DRAWING AE001 BASEMENT FLOOR PLAN

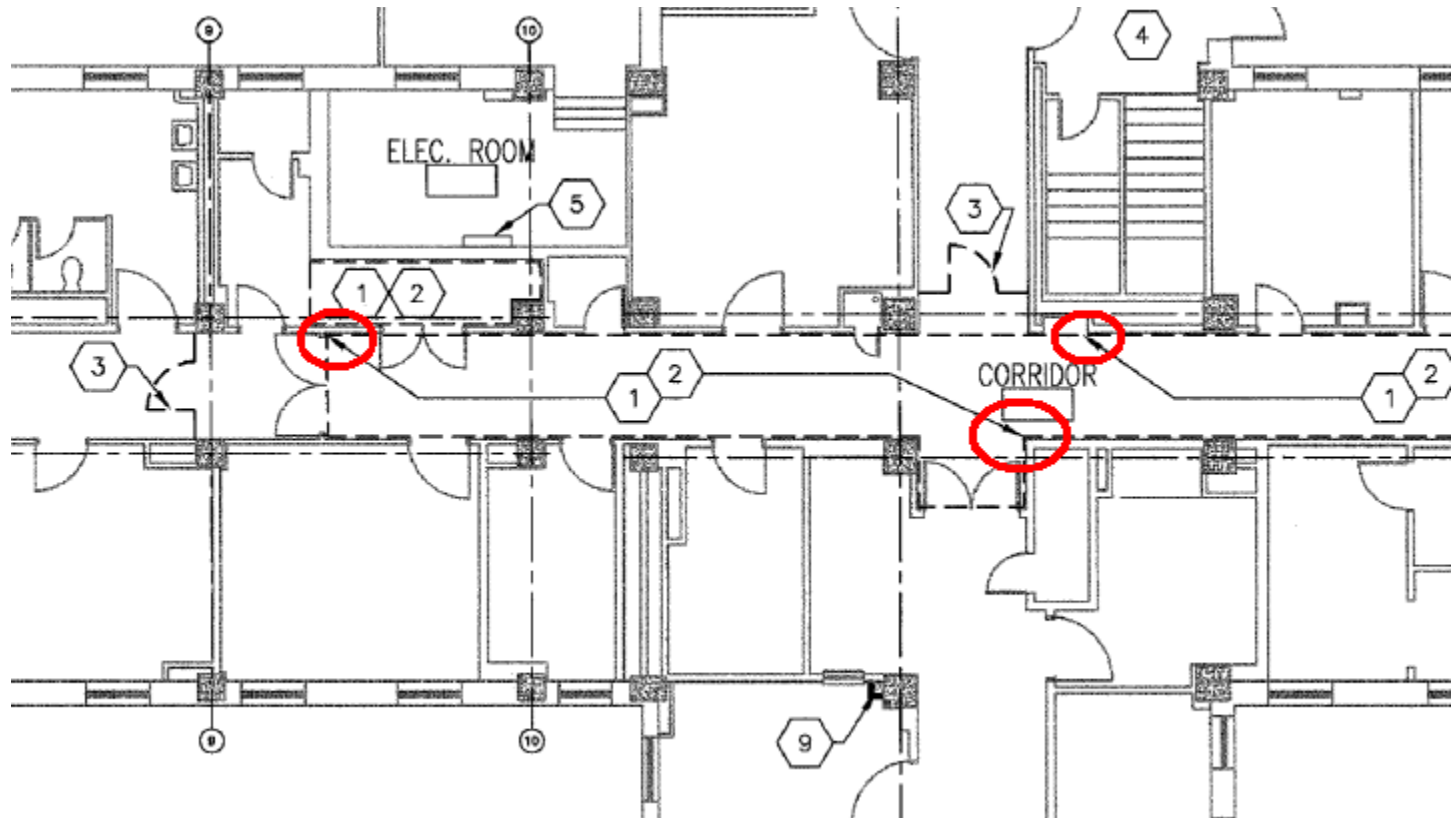
**Question 6:** Can Architectural Plan Notes 1 & 2 on drawing AE001 be confirmed; Ceiling Removal & new Ceiling?

Ceiling system removal and replacement confirmed for areas shown.

Ceiling system is removed to provide access for mechanical, plumbing, electrical or abatement work indicated elsewhere by the construction documents. It is replaced with new ceiling system upon completion of work requiring above ceiling access.

Coordinate ceiling removal and replacement with the various sub-contractor's requiring access above ceiling.

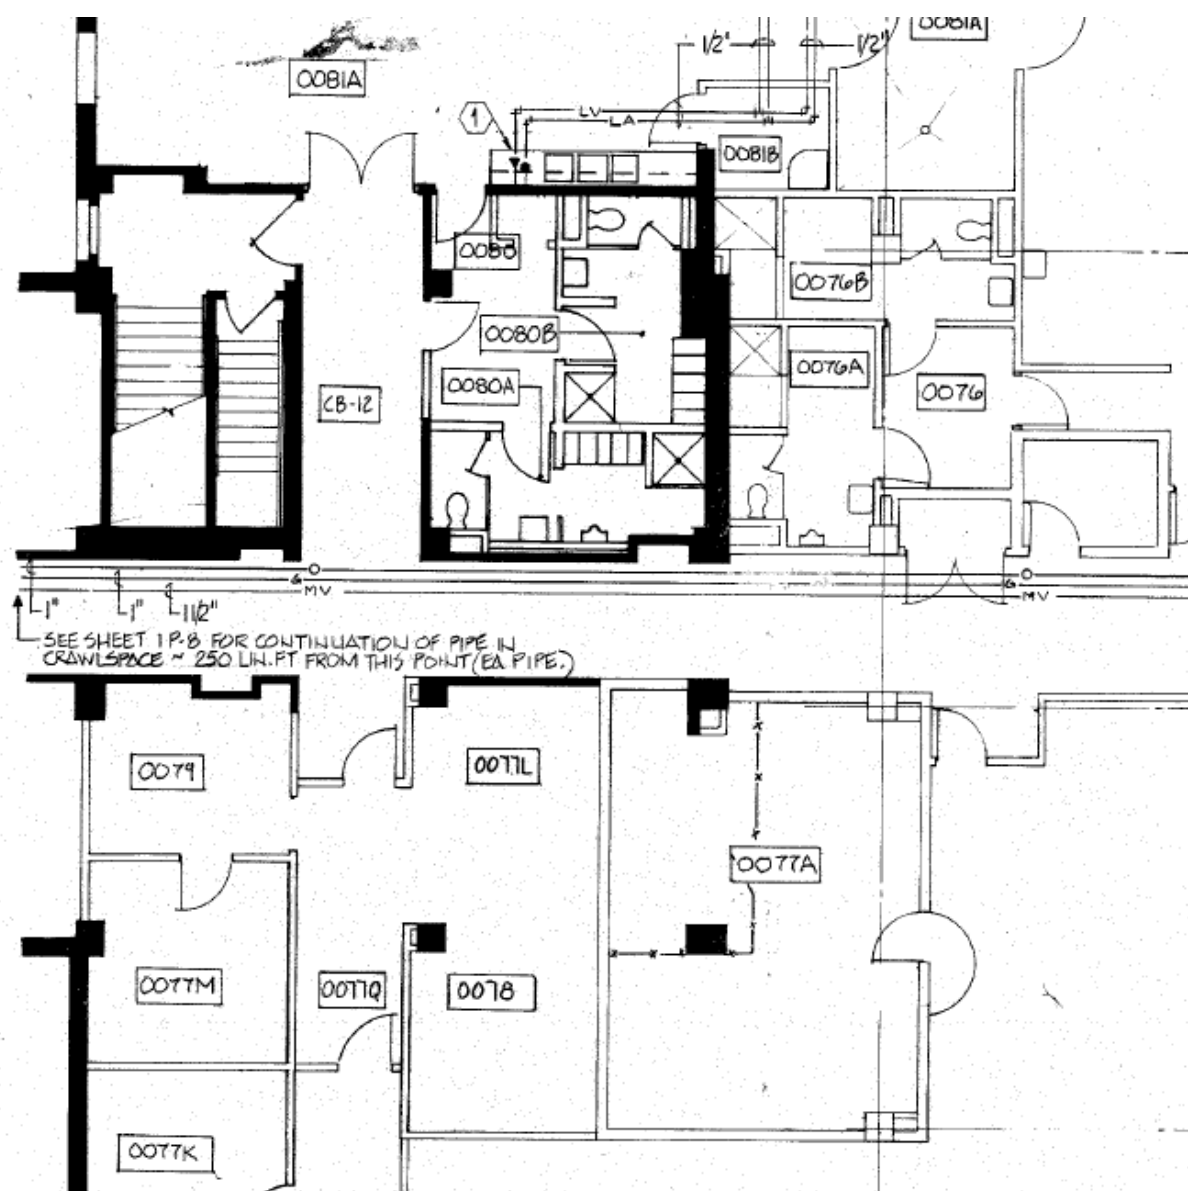
**Question 28:** Note 7 on Drawing PP108 indicates new medical gas piping up from below in the shaft located Mechanical Room 2B118. There are no drawings indicating what this piping is connecting to on the floors below.

New medical gas piping shall connect to existing med gas lines located where shown by attached sketch (below).
